Rodeo Renewed Project

Final Environmental Impact Report

March 2022

VOLUME II of II

Figure 3-7. Rodeo Renewed Project Flows Post Project Flows

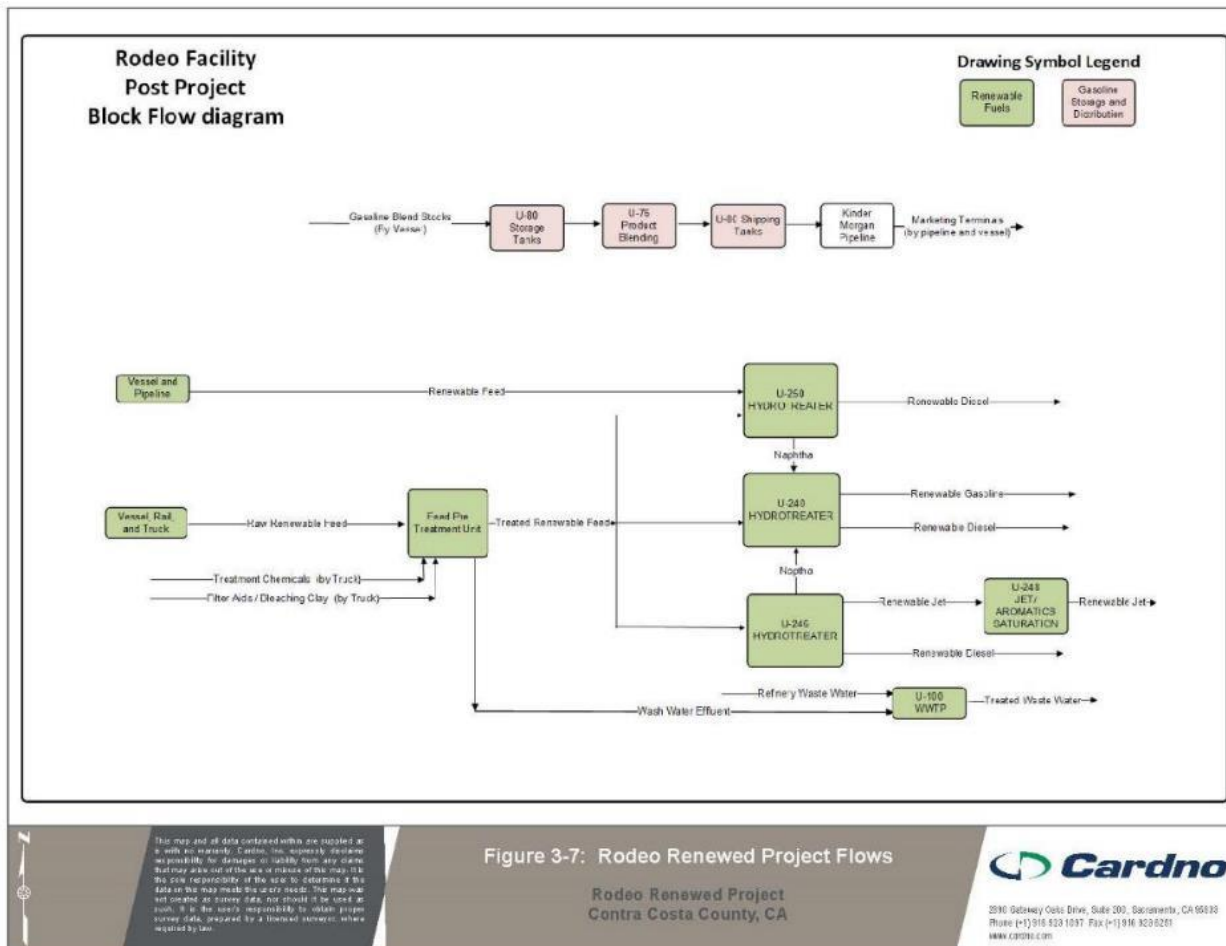
The title for Figure 3-7 is not accurate. Figure 3-7 is revised as follows:
